AGENDA
MAY 5, 2026
LAVON CITY COUNCIL
CITY HALL, 120 SCHOOL ROAD, LAVON, TEXAS
REGULAR MEETING
6:30 PM

C. Approve the preliminary plat of the 205-78 Addition consisting of two commercial lots on 5.133 acres out of the W.A.S. Bohanan Survey, Abstract No. 121, situated south and west of the intersection of SH 78 and SH 205and north and east of Grand Heritage - West C Addition, City of Lavon, Collin County, Texas (CCAD Property IDs 2675083, 2826863, 2882966, and 2664025).

C. Discussion and action regarding the preliminary plat of the Elevon Section 3A Addition, Phases 3A-1, 3A-2, 3A-3, 3A-4, and 3A-5 consisting of 561 residential lots, 1 amenity center common area, 1 wastewater lift station lot, and 22 common areas on 172.014 acres out of the Samuel M. Rainer Survey, Abstract No. 740, situated adjacent to and east of Elevon, Section 2, Phase 2E north of the extension of Elevon Parkway, City of Lavon, Collin County, Texas (CCAD Property IDs 2961759 and 1290034).

Exhibit A. Location Map

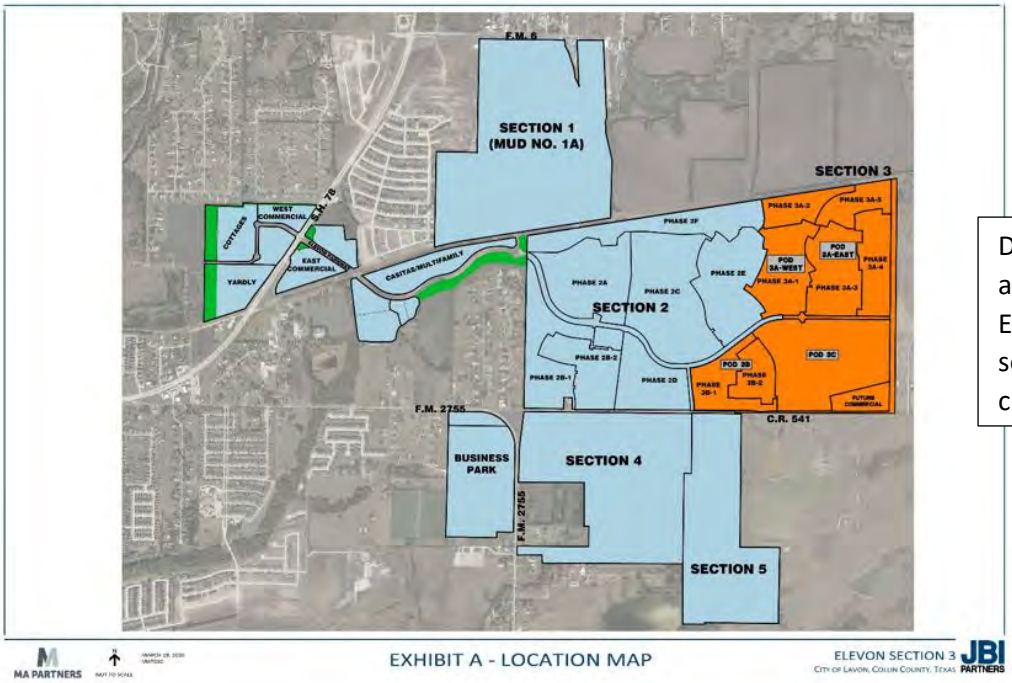
Draw a heavy line weight around the Section 3A East boundary. All other sections should be changed to blue.

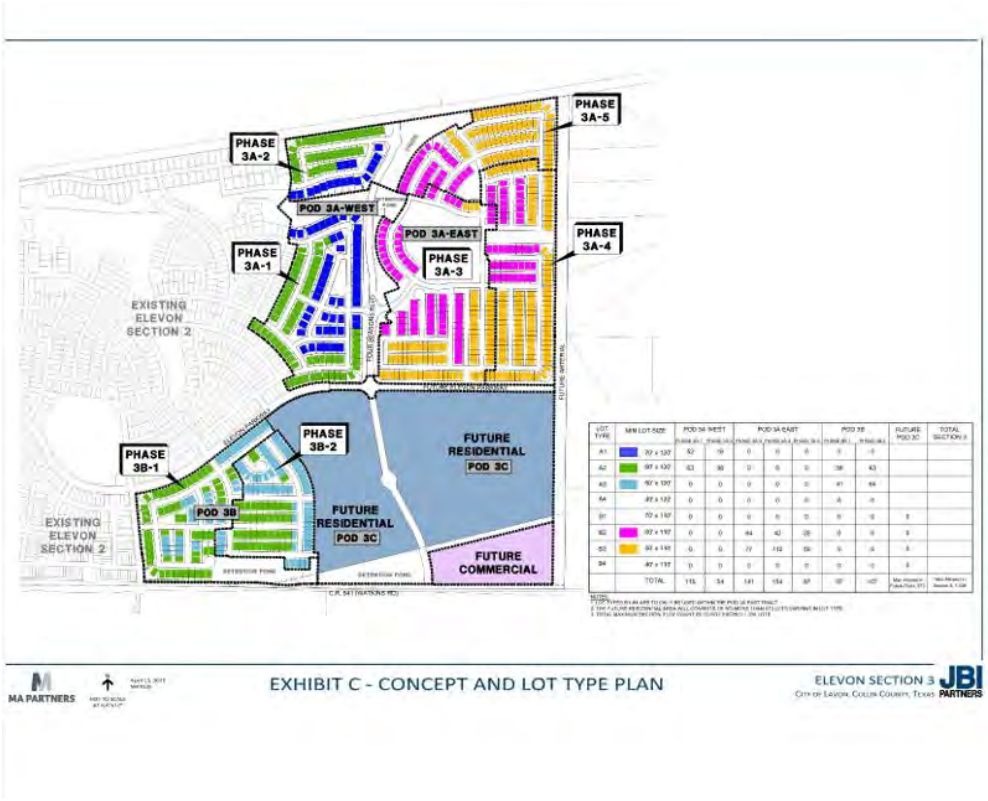
Draw a heavy line weight around the Section 3A East boundary. All other sections should be shown similar to how Section 2 is shown (in gray and with or without lot layouts, depending on plat status).

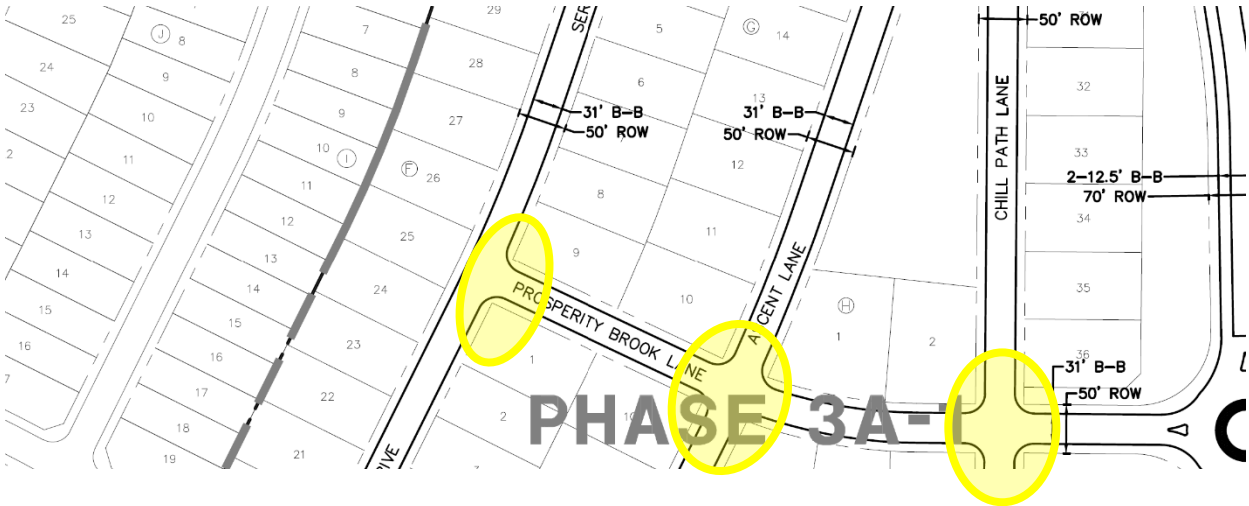
4. **Repeat comment**: Confirm the corner clip configurations are acceptable with the City Engineer. Sidewalk minimum widths and ADA accessibility standards will need to be reviewed at all intersections, as applicable. Revisions to the Paving Plan and Preliminary Plat may be required. (Example from Paving Plan below.)

Applicant response: Sidewalk visibility easements are provided on the plat at the lot corners to cover sidewalks and ramps encroaching onto the lots.

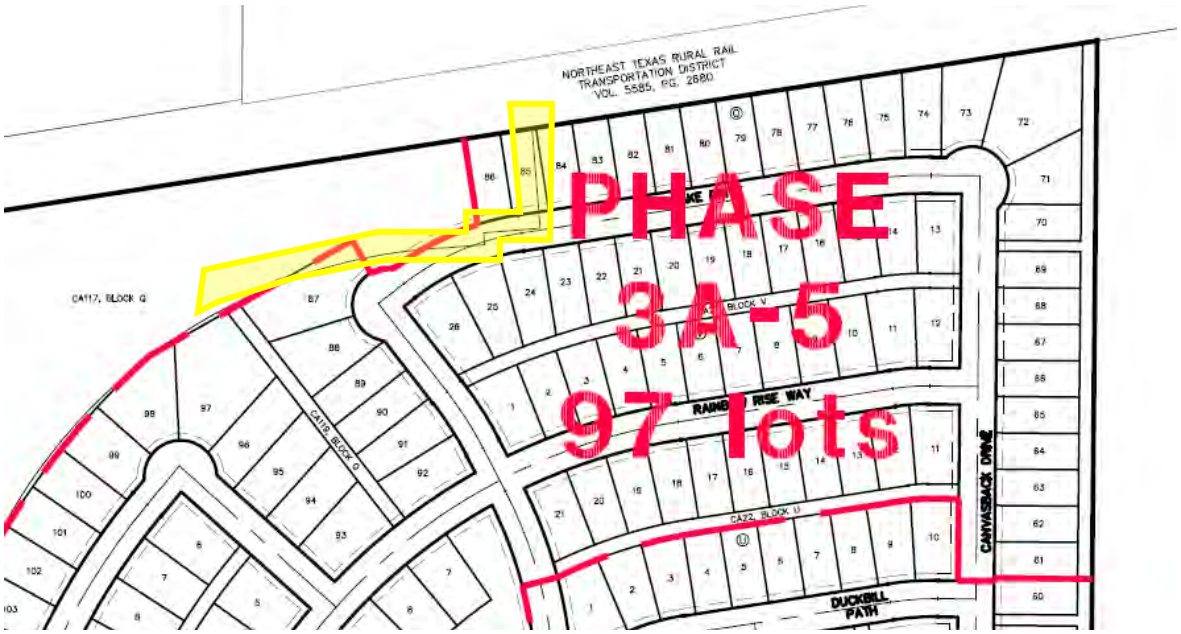
3. Sheet 1 shows extra linework not related to this Plat. Revise to remove the highlighted lines on Sheet 1 and subsequent areas that appear on Sheet 2 and Sheet 3 for this site.

3. Sheet 1 shows extra linework not related to this Plat. Revise to remove the highlighted lines on Sheet 1 and subsequent areas that appear on Sheet 2 and Sheet 3 for this site.
   The extra linework previously shown were the tract deed lines. The lines have been removed for the purpose of the preliminary plat.

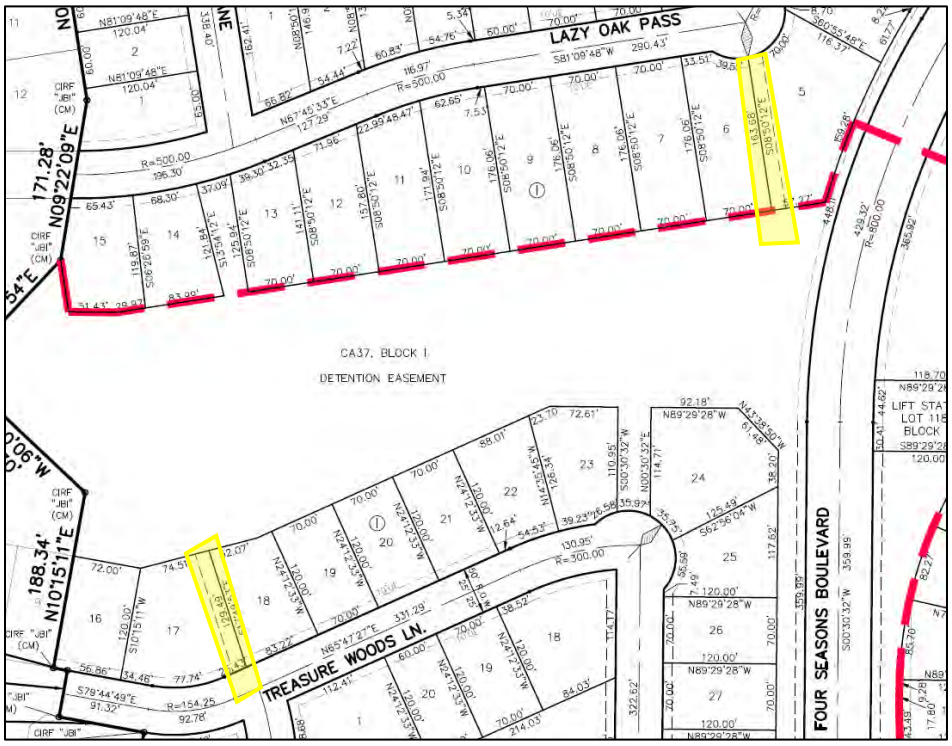
4. Sheet 2 shows areas with easement lines indicated on Lot 5 and Lot 17, Block I, and there is not a label to indicate the nature of the easements. Revise to remove or clarify.

4. Sheet 2 shows areas with easement lines indicated on Lot 5 and Lot 17, Block I, and there is not a label to indicate the nature of the easements. Revise to remove or clarify.
   The sanitary sewer and drainage easements are now labeled.

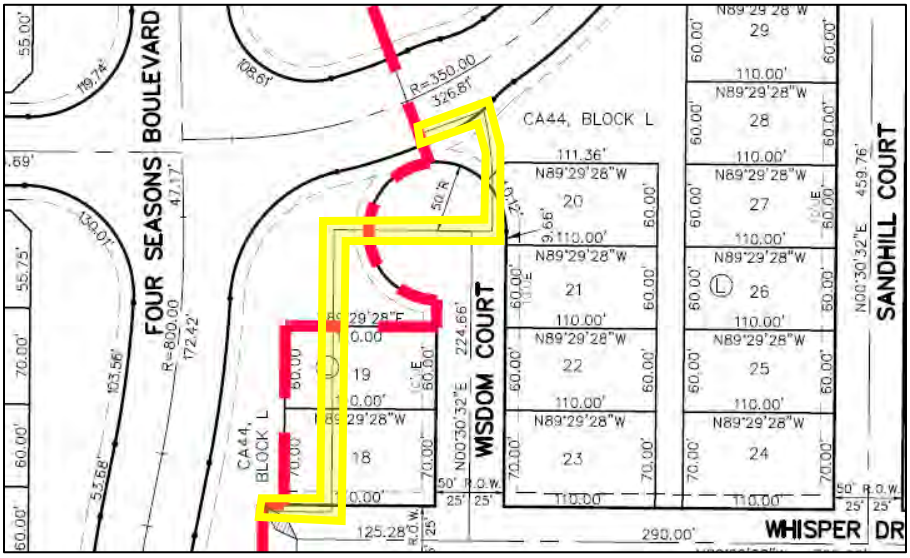
5. The area around the cul-de-sac at Wisdom Court includes some lines that do not have a reference. Revise the Plat to remove errant linework.

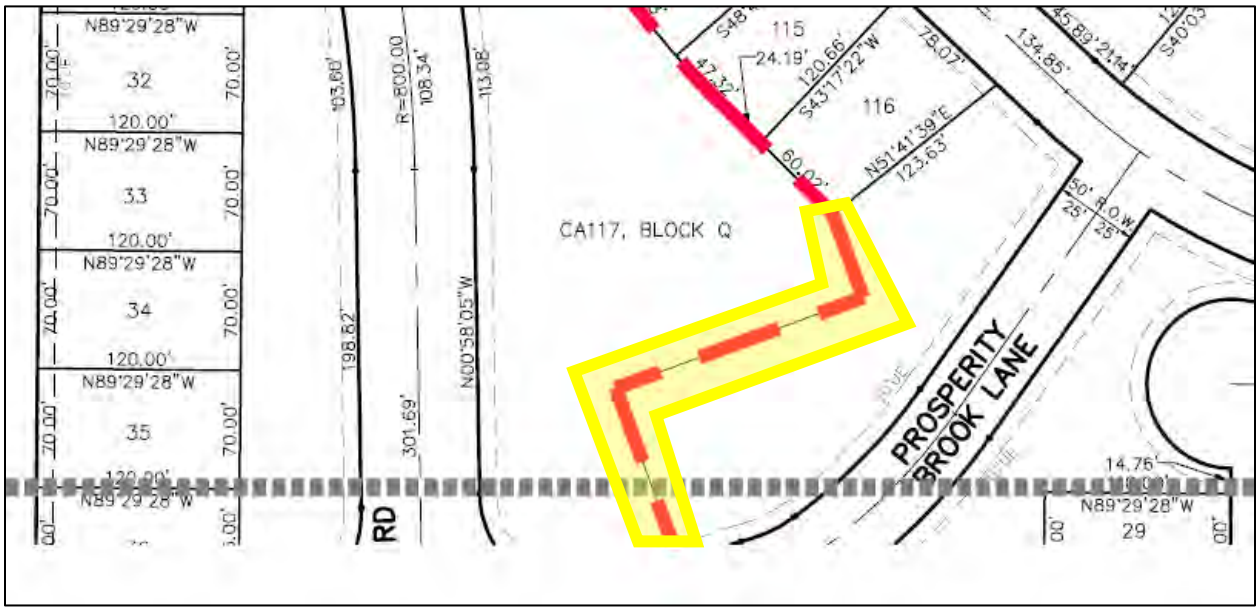
6. On Sheet 2, revise the line showing with the Phase line in CA 117, Block Q. It appears to be separating the CA117 parcel or label that space appropriately.

6. On Sheet 2, revise the line showing with the Phase line in CA 117, Block Q. It appears to be separating the CA117 parcel or label that space appropriately.
   Since the Phase 3A-1 final plat is already approved, to avoid changing the phase line, the common areas are now both labeled with different lot numbers.

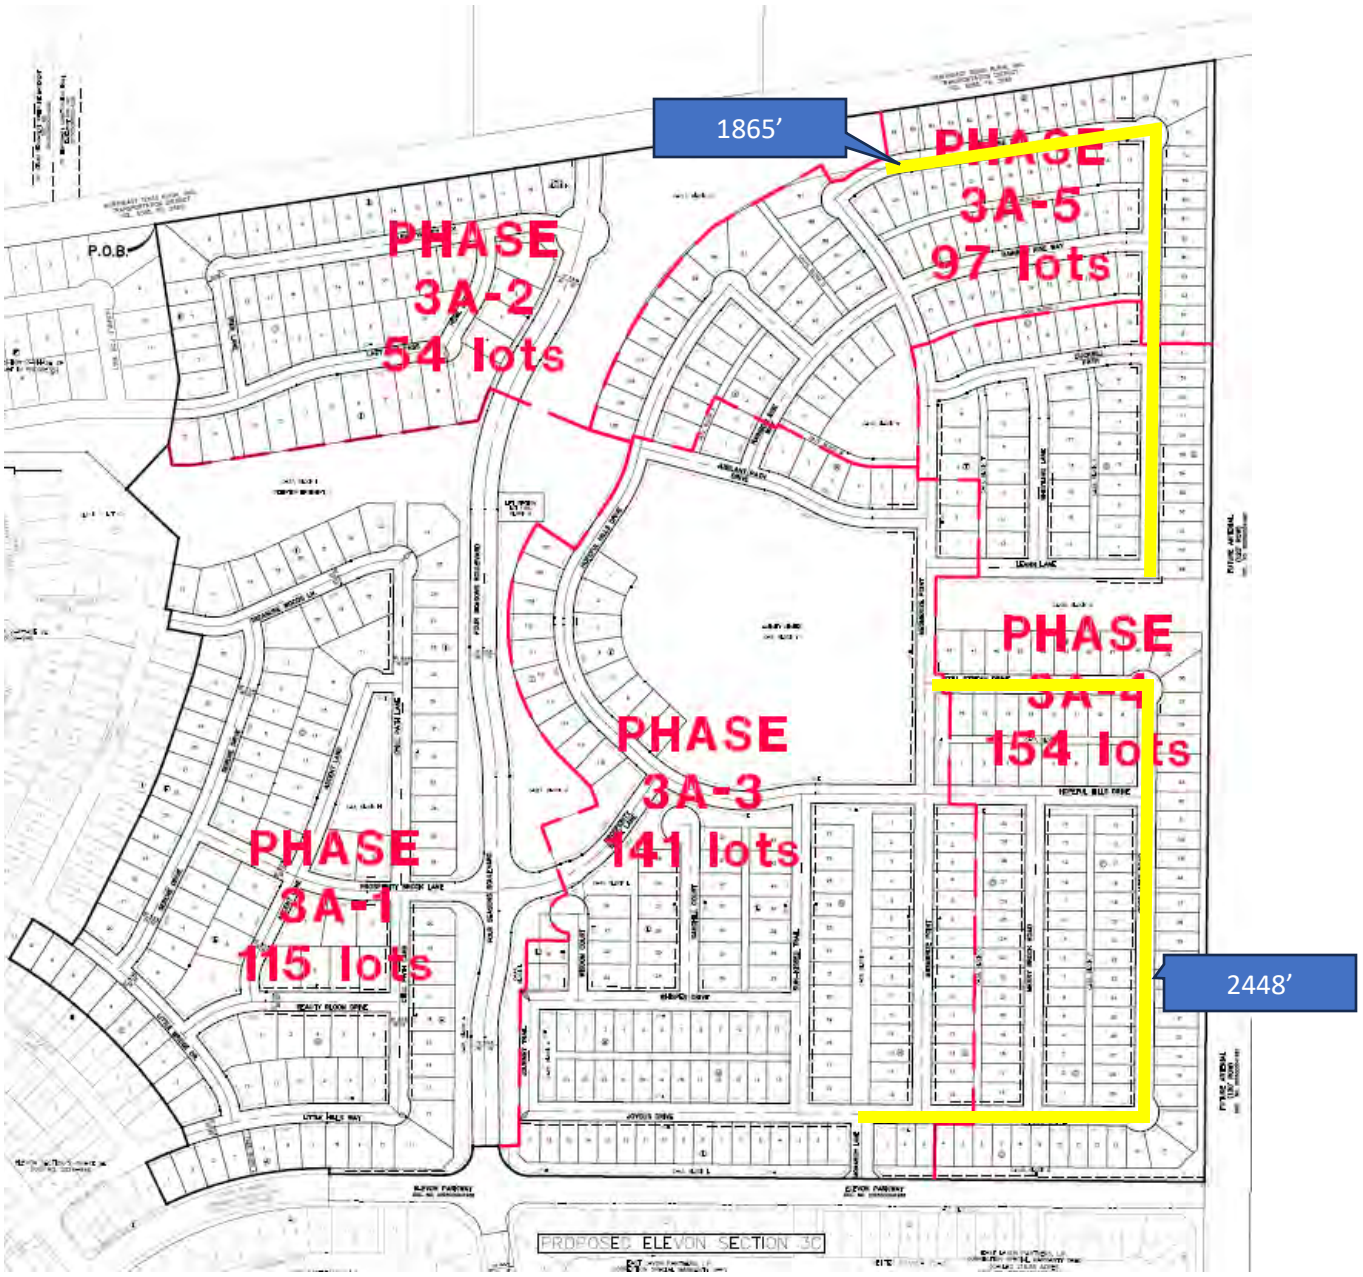
7. The blocks highlighted in the next graphic exceed the maximum block length standard of 1,000 feet, per the Development Agreement.

b. FYI – The northeast area in Phase 3A-5 was modified but the length is shorter than the previous approval and is generally consistent with the prior approval.

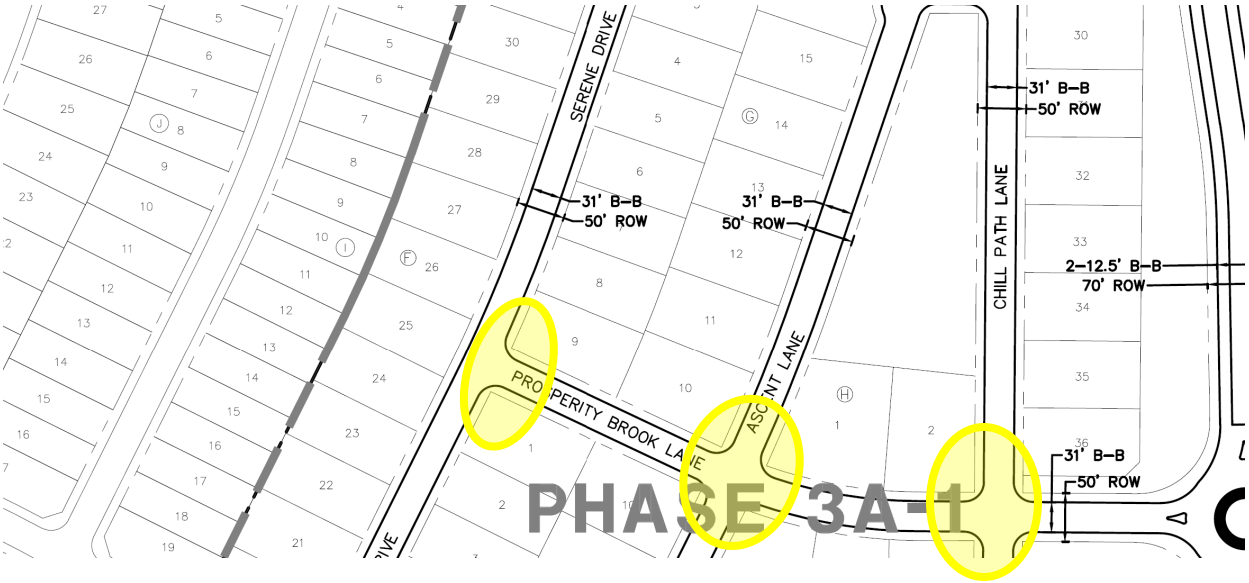
intersections, as applicable. Revisions to the Paving Plan and Preliminary Plat may be required. (Example from Paving Plan below.)

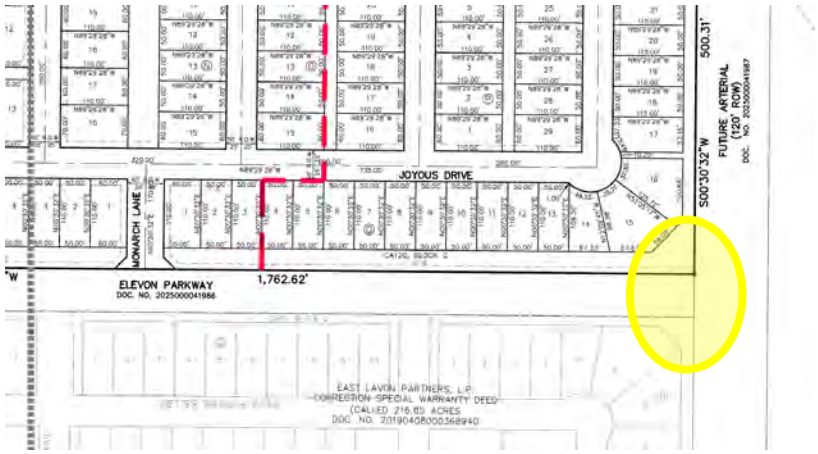
11. At the eastern terminus of Elevon Parkway, please confirm with the City Engineer and Fire Marshal if a temporary turnaround will be required.

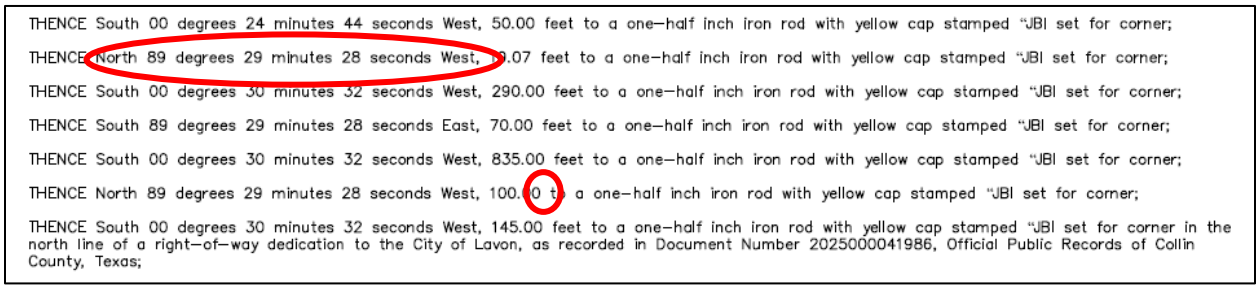
7. The Legal Description on Sheet 2 has four errors, indicated below. Please review the Legal Description and ensure that it is accurate to the survey and that the metes and bounds description has an error of closure not to exceed one in ten thousand. Provide a copy of the traverse closure sheet and revise the following:

- Provide "West" to indicate the direction

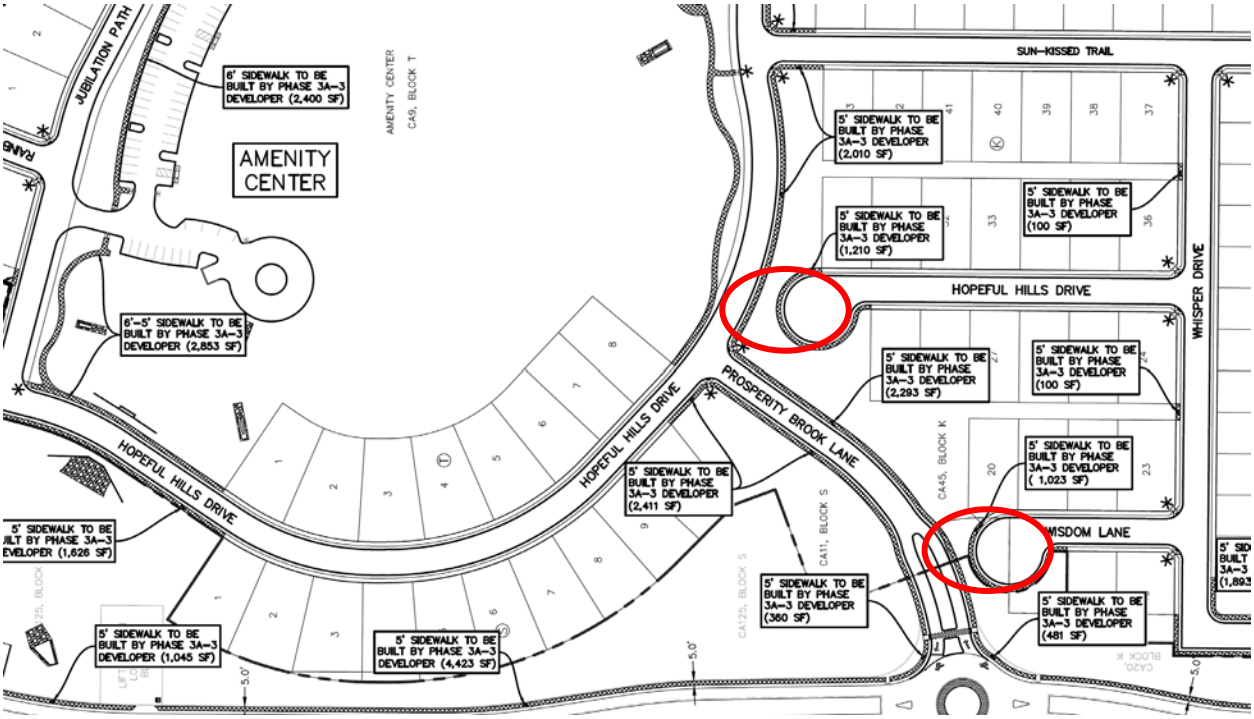
8. The Sidewalk Plan, Civil Set Sheet 1.18, has cul-de-sac Sandhill Court incorrectly labeled as Hopeful Hills Drive. Revise to match the Final Plat. Also, consider providing a sidewalk connection between the cul-de-sac at Wisdom Lane to Prosperity Brook Lane and from Sandhill Court to Hopeful Hills Drive. This would improve the pedestrian access to the Amenity Center and within the subdivision and support the active lifestyle the subdivision is wanting to provide.

8. The Sidewalk Plan, Civil Set Sheet 1.18, has cul-de-sac Sandhill Court incorrectly labeled as Hopeful Hills Drive. Revise to match the Final Plat. Also, consider providing a sidewalk connection between the cul-de-sac at Wisdom Lane to Prosperity Brook Lane and from Sandhill Court to Hopeful Hills Drive. This would improve the pedestrian access to the Amenity Center and within the subdivision and support the active lifestyle the subdivision is wanting to provide.
   The sidewalk plan has been updated with the latest sidewalk/tail layout from landscape. There are sidewalk connections between the cul-de-sac and Prosperity Brook Lane now provided. The trail within the linear park is also now shown.

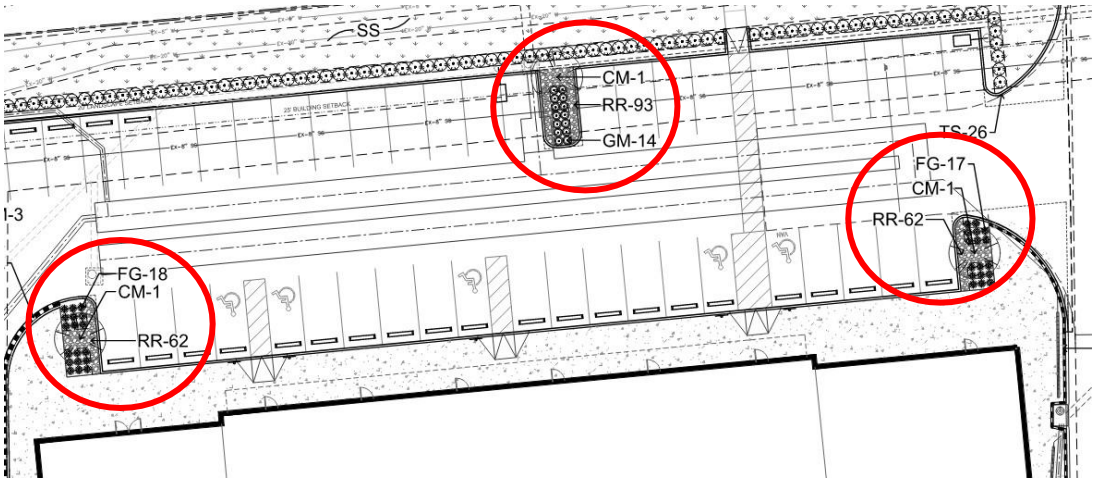
9. The landscape islands and landscape buffers require canopy trees. The landscape plan shows Crepe Myrtle trees within the landscape islands and landscape buffers; however, Crepe Myrtle trees are not an approved canopy tree per Section § 9.03.193 of the zoning ordinance. Revise the landscape plan to provide an approved canopy tree within these locations. An example is shown below.

Response: Per comment #1 on this document, the canopy tree requirement along SH 78 has been deferred to the engineer and is engineering exempt from the tree requirement due to the many utilities in the area. The landscaping islands in front of the building will be planted with Cedar Elm as opposed to Crepe Myrtle to meet the canopy tree requirements.
